VALUE ENGINEERING TEAM STUDY REPORT

Greenup Lock

OHIO RIVER

Sponsored By:
U.S. Army Engineer District, Huntington

PROPOSED DESIGN WITH THREE STRIPS OF ARMOR

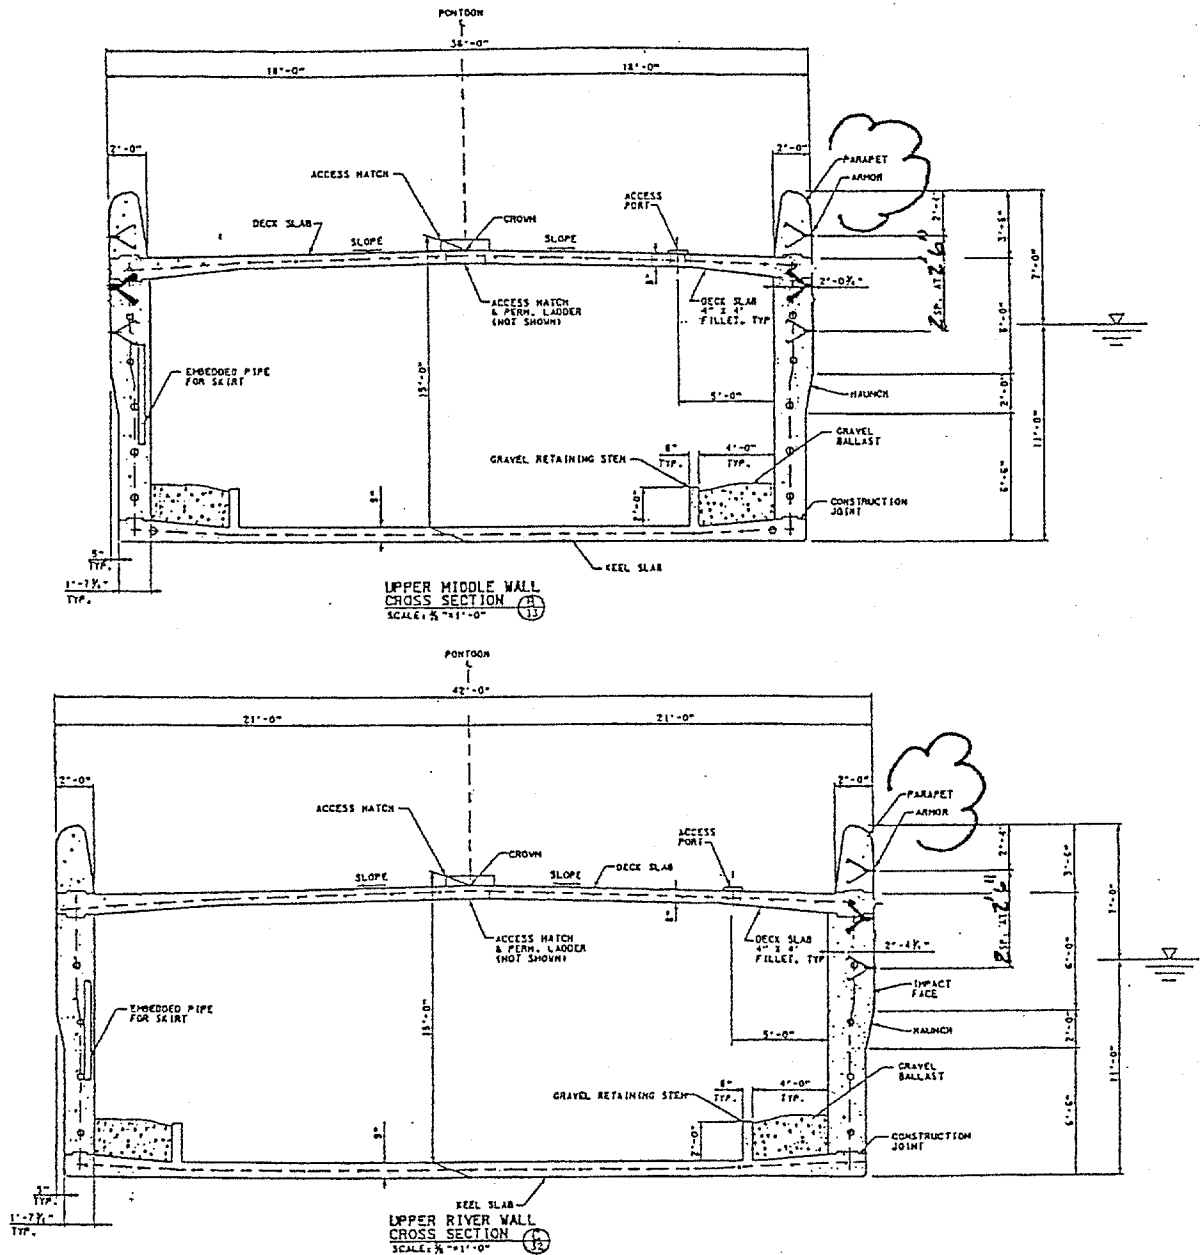
Armor appears to be spaced too closely. Dimensions should be more closely match those of the width and centerline spacing of armor strips on the existing lock walls.
